RE: DA2019/1173 - 3 Berith Street Wheeler Heights NSW 2097

To whom it may concern, DA2019/1173 3 Berith St

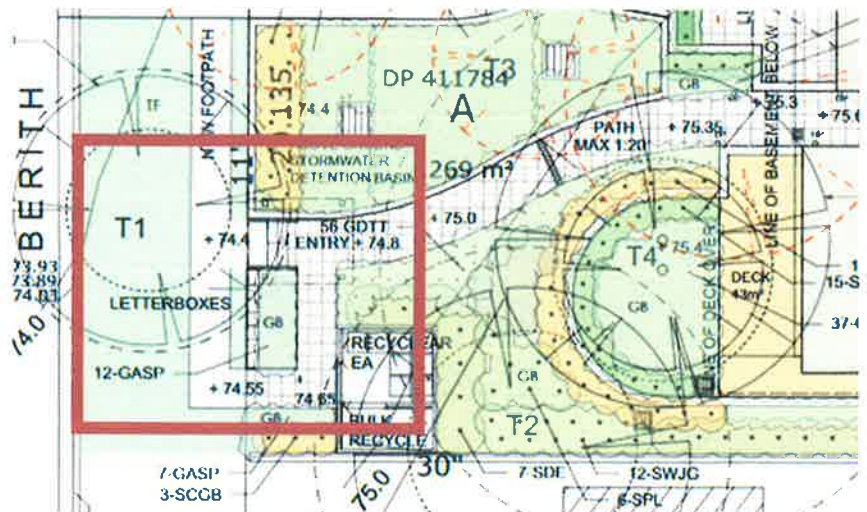
On the Site/Ground Floor Plan T1 is shown as right in the middle of the only designated accessible entry/exit to the complex. See right.

The roots are very large, and above the ground, right across the path and into the block

T1 Liquidambar styraciflua (Liquidamba), an Exemption Species, must be removed

to ensure that over 55s and people with disabilities using electric wheelchairs, motorised carts or the like, or pushing grandchildren in strollers will be able to safely collect their mail, take out their bins and go to the shops or bus stop in perpetuity.

As council is aware, cutting back the roots of Liquidamba and putting a 'concrete path pavement'**** over them will not stop the roots from rapidly lifting the cement and again posing a significant trip hazard making accessibility impossible for the over 55s or people with disabilities using electric wheelchair, motorised cart or the like trying to access transport, shops or mail. And bitumen is not a viable solution for what will be a busy path used by people in wheelchairs, with walkers or motorised carts.
